**AGENDA**  
**Cascade Charter Township Planning Commission**  
**Monday, October 19, 2015**  
**7:00 pm**  
**Cascade Library Wisner Center**  
**2870 Jacksmith Ave. SE**

TO: Cascade Charter Township Planning Commission  
FROM: Steve Peterson, Community Development Director  
REPORT DATE: October 13, 2015  
MEETING DATE: October 19, 2015  
CASE: #15-3260 / Lacks Corporate HQ expansion

Re: Lacks Corporate Office  
Site Plan Review

NO.	DATE	DESCRIPTION

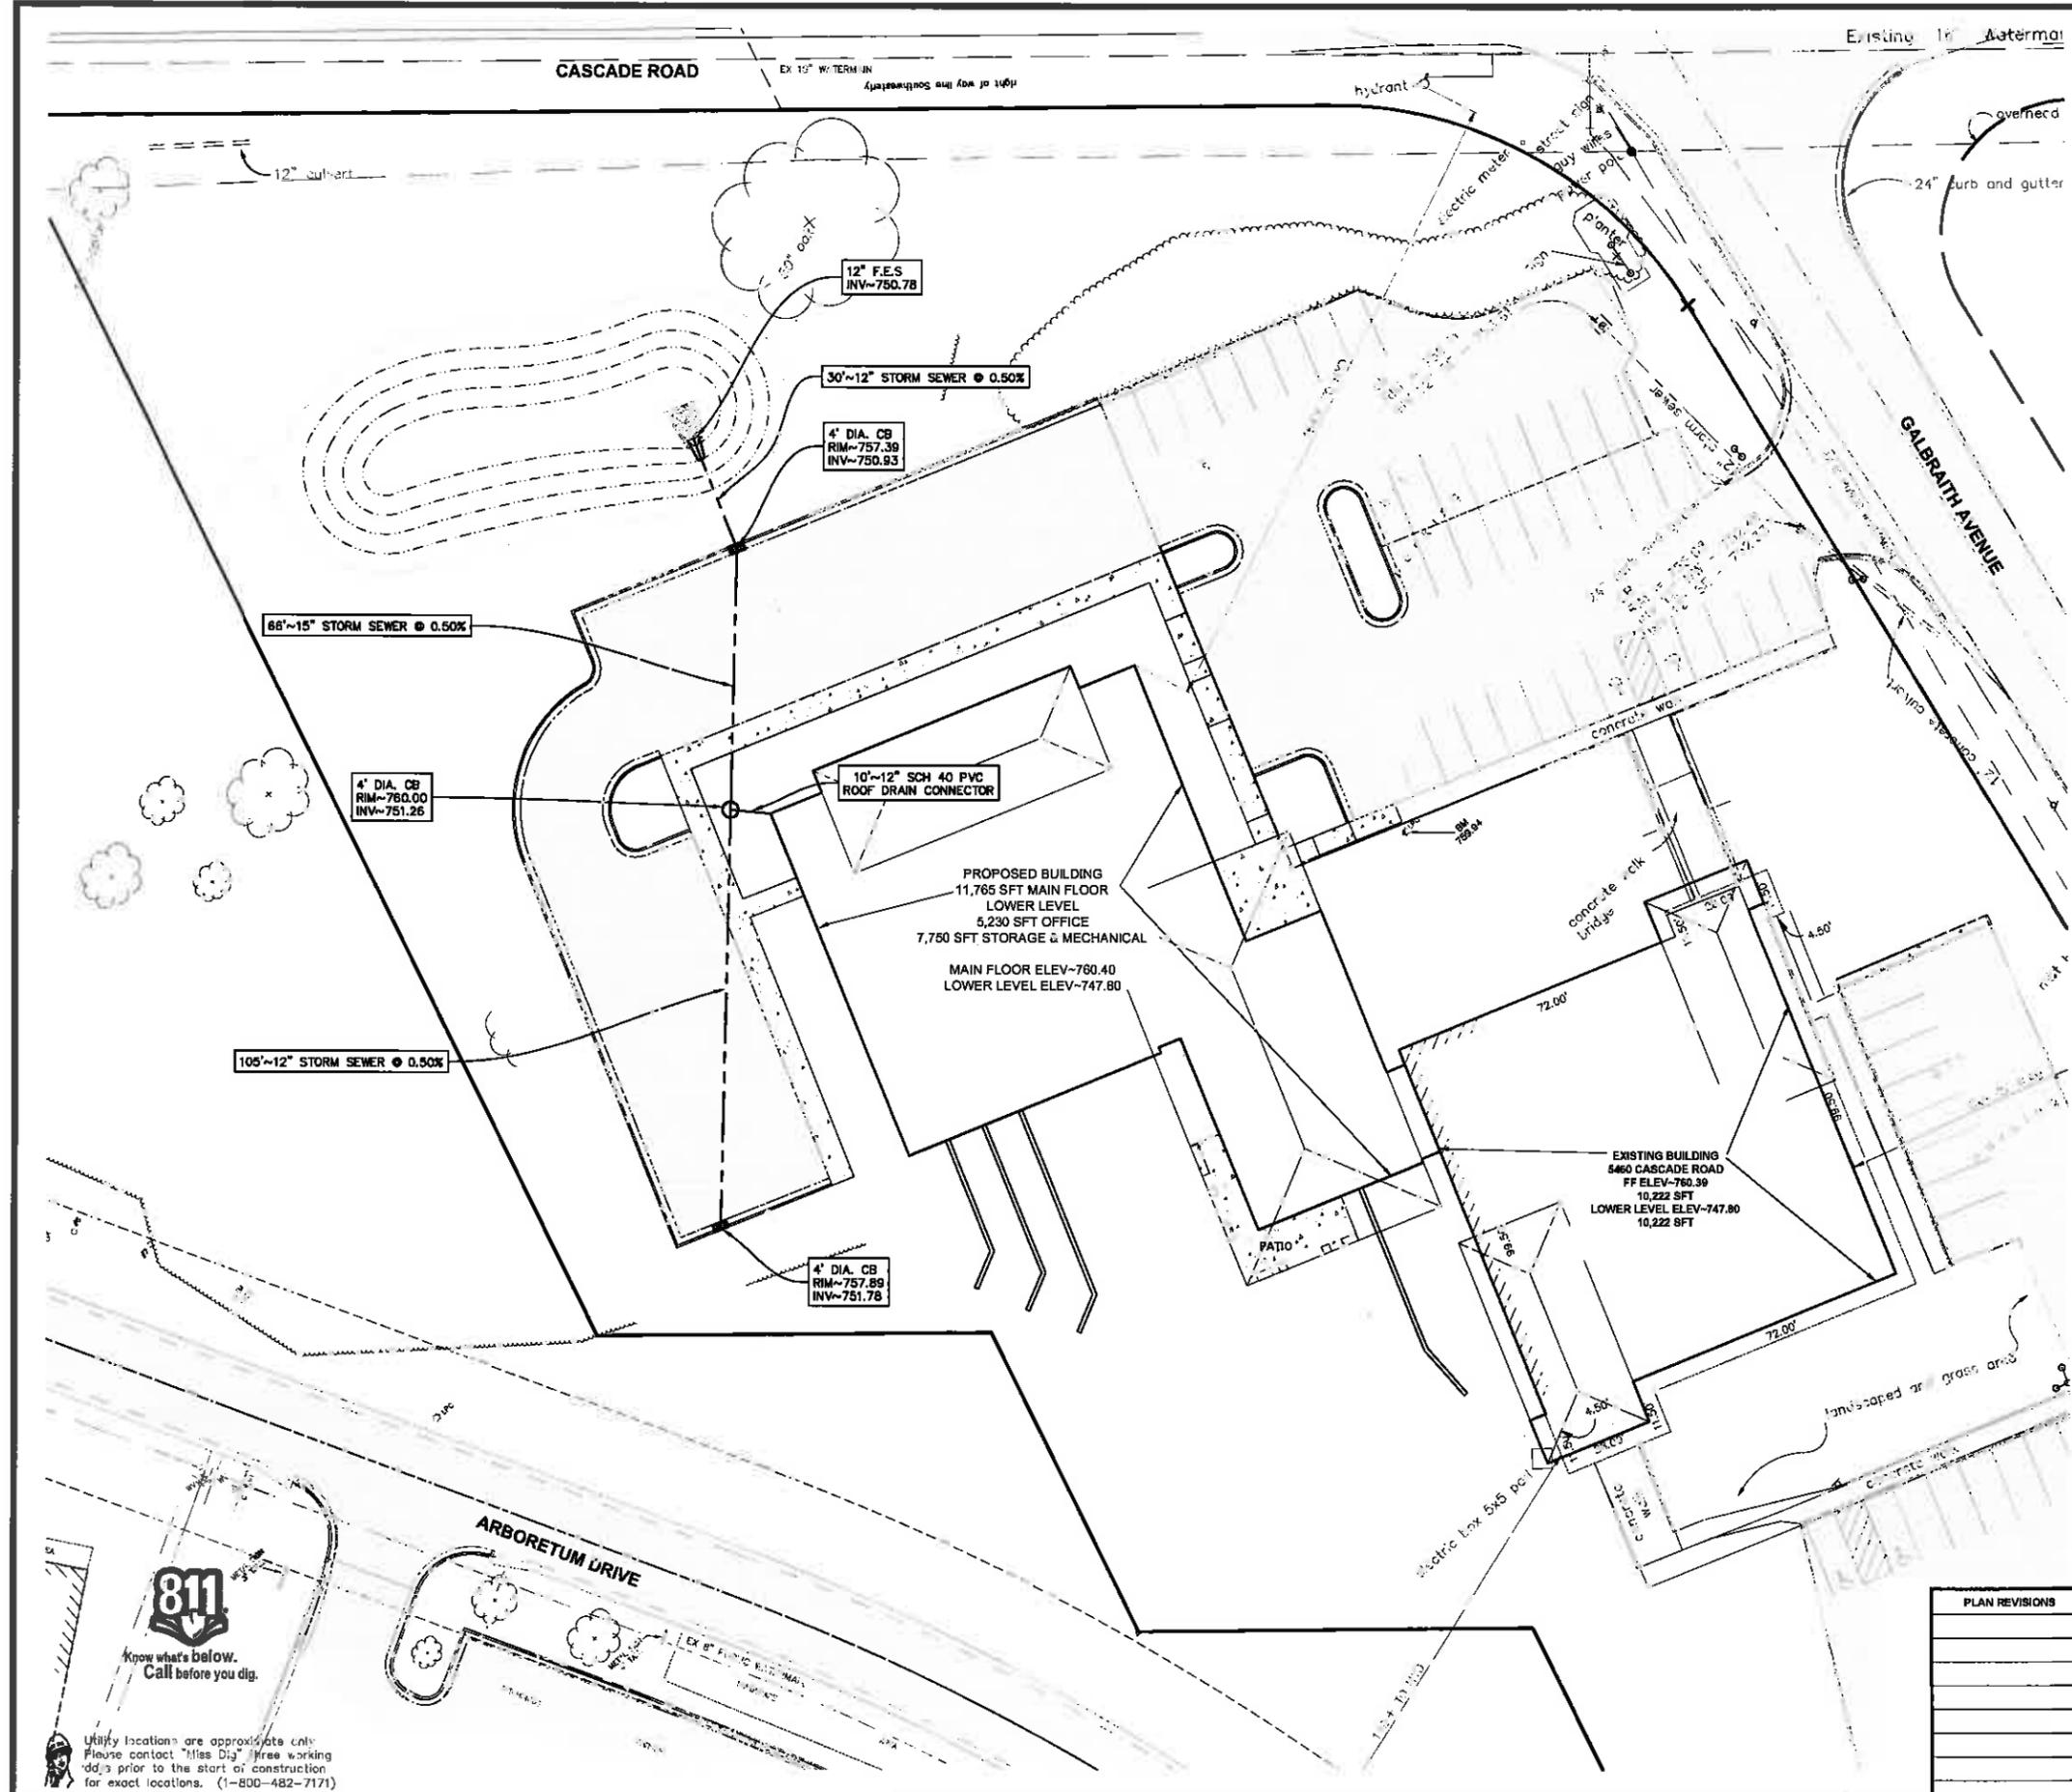
We reviewed the site plan for the Lacks Corporate Office, located at 5460 Cascade Road, prepared by Moore and Bruggink, Inc. The current site plan and the basis of this review are dated September 25, 2015. The proposed project includes a 24,745-square-foot building addition, parking lot expansion, and storm sewer improvements.

The applicant has submitted drawings, calculations, and additional documentation as required in the SWO Section 2.03, Drainage Plan. Please refer to the attached checklist for items and comments on each item. Please note a maintenance agreement is required before construction begins. The agreement should be submitted to the Township for review. The maintenance agreement and plan should include at a minimum, cleaning of catch basin sumps, sediment and debris removal from the infiltration basin, and landscape maintenance of the infiltration basin to maintain the design volume and ensure the system is operating as it was designed.

Soil Erosion and Sedimentation Control (SESC) measures are provided on the plan drawings. The applicant has included silt fence along the limits of clearing and grading, silt sacks in catch basins, and seeding with mulch at all disturbed areas of the site. SESC falls under the review and approval of the Kent County Road Commission and a permit is required before construction can begin. The SESC measures indicated on the drawings appear appropriate given the expected work.

The proposed stormwater design meets the Township SWO requirements for new developments. The applicant will need to apply for and obtain an SESC permit prior to beginning construction. We recommend approval of the site plan from an engineering standpoint.

- NR (11) Maintenance agreement, in form and substance acceptable to the Township, for ensuring maintenance of any privately owned stormwater runoff facilities. The maintenance agreement shall include the developer's written commitment to provide routine, emergency, and long-term maintenance of the facilities and, in the event the facilities are not maintained in accordance with the approved drainage plan, the agreement shall authorize the Township to maintain any onsite stormwater runoff facility as reasonably necessary, at the developer's expense  
*Maintenance agreement was not provided and is required.*

Listed below are items from the site plan review:

- Fire Lanes will be determined by the Fire and Building code Officials.
- Access to the site at all times during construction.
- Hydrants and spacing will be determined by the fire code official and the City of Grand Rapids water department. On plan hydrants are difficult to find, 300 feet spacing along access roads.
- Fire Department Connection (FDC) will be a 5" Stortz fitting with a 30 degree elbow.
- Address posted and visible from the roadway.
- Supra box installed for 24 hour access by Fire Department staff in case of an emergency.
- Access will need to be for fire trucks from Galbraith to Arboretum thru the new parking lot. Appears there are parking spaces on the plan.
